**RE: Revised Traffic Control Plan for Lamar CISD (Dickinson Elementary) in
Greatwood Glen, Section 2 to Establish "No Parking" Signs**

Re: Signing improvements for Lamar Consolidated ISD Dickinson Elementary

PROPOSED SIGNING
DICKINSON ELEMENTARY SCHOOL
FORT BEND COUNTY, TEXAS

**Dickinson Elementary School
(Greatwood Glen, Section 2)
Control Map and Traffic Sign
Layout**

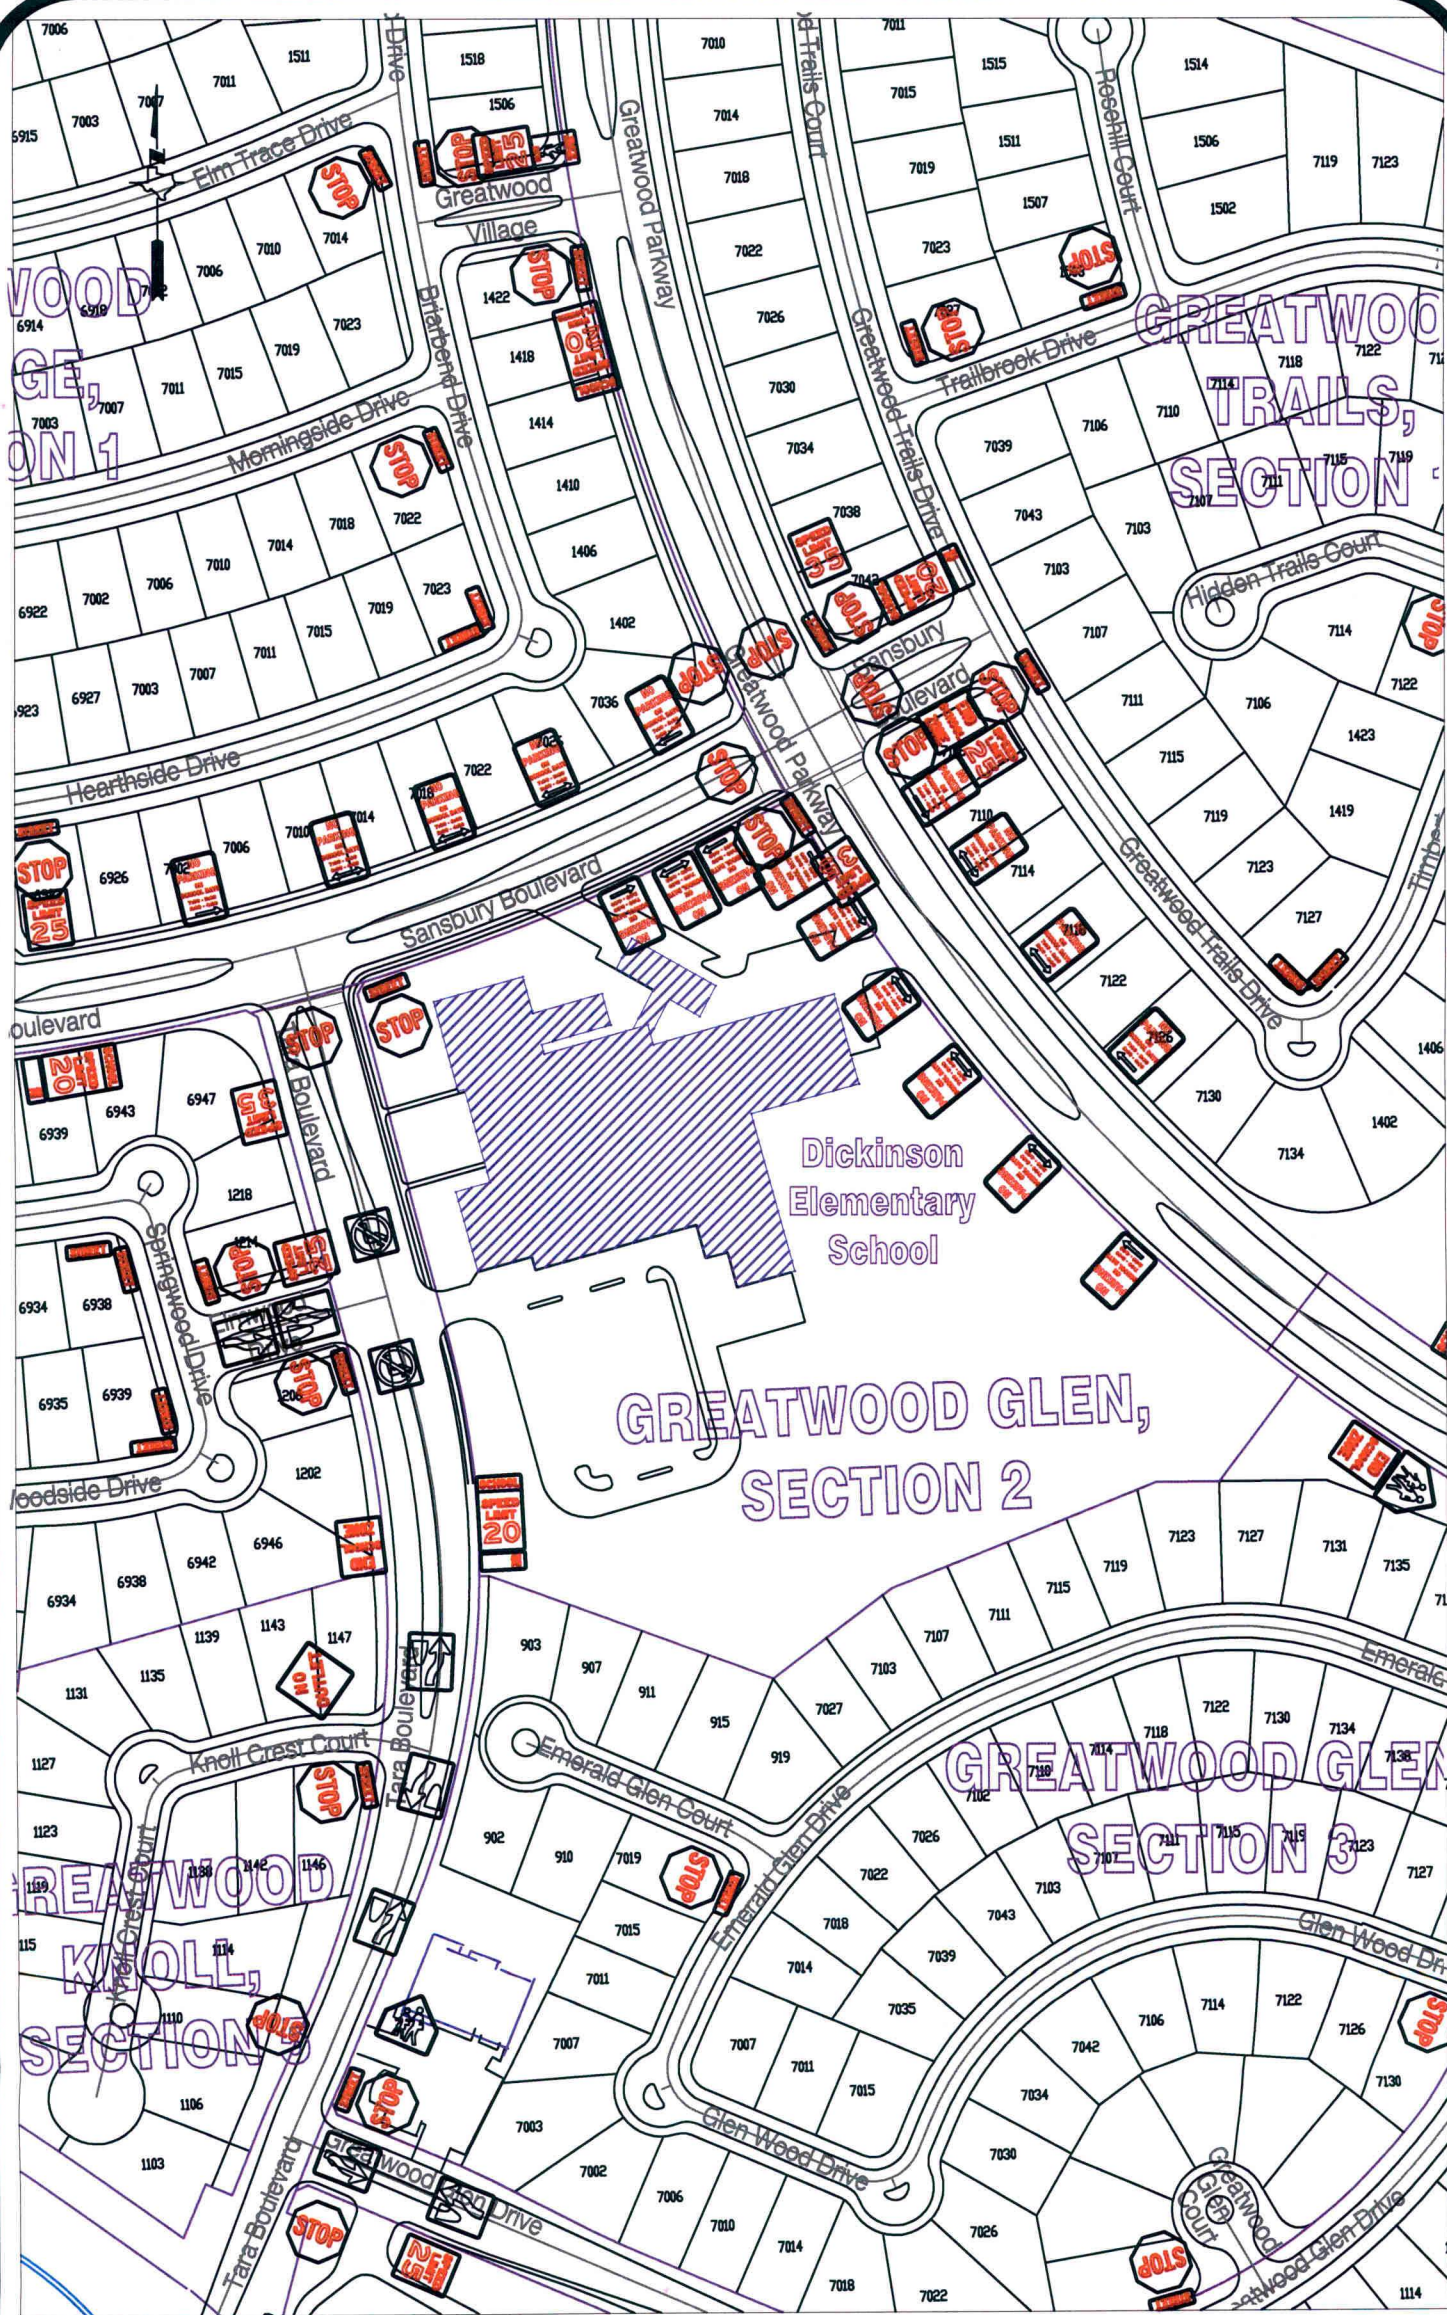
1. Installation of "No Parking" signs on southbound Greatwood Parkway, between Sansbury Blvd. and the school driveway because of sight distance issues for parents exiting the school driveway caused by parents parked on Greatwood Parkway to walk their student to and from the school building. Installation of "No Parking" signs on southbound Greatwood Parkway, south of the school driveway. The inside southbound lane of Greatwood Parkway, south of the school driveway, was blocked at times because of vehicles u-turning at the median opening located south of the school driveway at the same time that vehicles were parked in the outside lane on Greatwood Parkway while the parents walked their student to or from the school building.

2. Installation of "No Parking" signs on northbound Greatwood Parkway, between Sansbury Blvd. and the median opening south of the school driveway because a few parents were observed parking on northbound Greatwood Parkway and walking their student to or from the school building.

3. Installation of "No Parking" signs on eastbound Sansbury Blvd. between Greatwood Parkway and the school driveway because a few parents were observed parking on eastbound Sansbury Blvd. and walking their student to or from the school building.

4. Installation of "No Parking" signs on westbound Sansbury Blvd. between Greatwood Parkway and Tara Plantation Drive because a few parents were observed parking on westbound Sansbury Blvd. and walking their student to or from the school building.

5. Installation of a "No U-Turn" sign on southbound Tara Plantation Drive at the median opening at Tara Boulevard and the school driveway. Parents were observed waiting in the median opening to U-turn and get in the queue of parent vehicles on northbound Tara Plantation Drive. They waited in the median opening until the queue was north of the school driveway. There is currently a "No U-Turn" sign on westbound Sansbury Blvd. at the Tara Plantation Drive median opening to prevent parents from U-turning to access the school driveway.

I would like to request that Fort Bend County install the signs recommended by Traffic Engineers, Inc. as shown on the attached figure.
